AppIn No. 10/736,751
Amendment dated November 2, 2005
Response to Office action of May 2, 2005

Amendments to the Drawings:

Remarks/Arguments:

FIG. 4

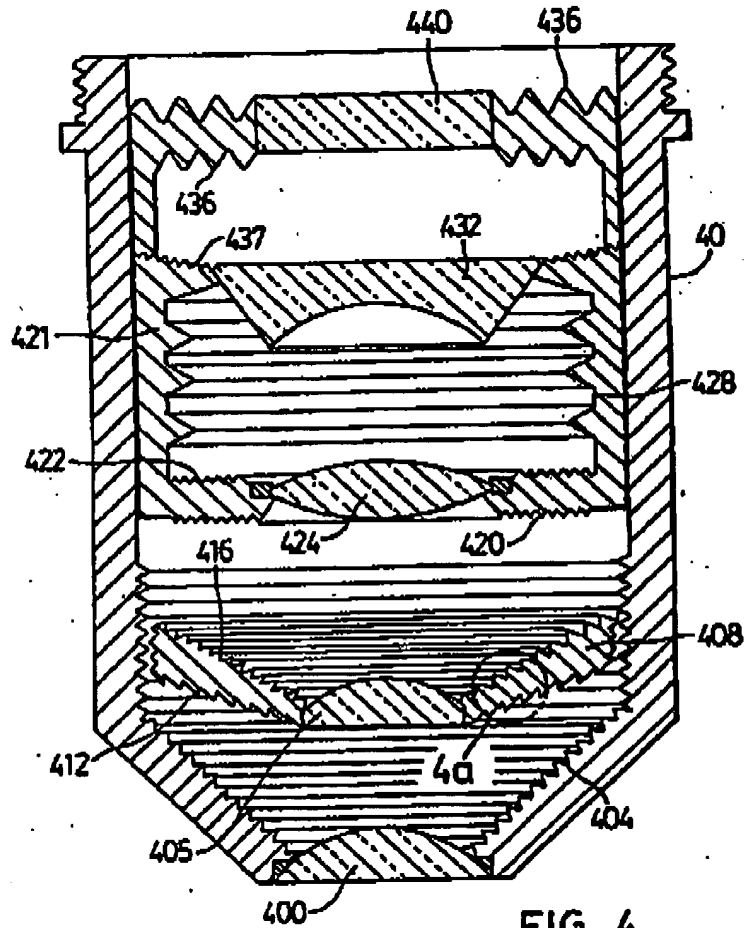
In Figure 4a, numerical references "452" and "456" have been deleted.

Numerical references "452" and "456" have been deleted from Figure 4a. Applicant believes this meets the objection to this figure.
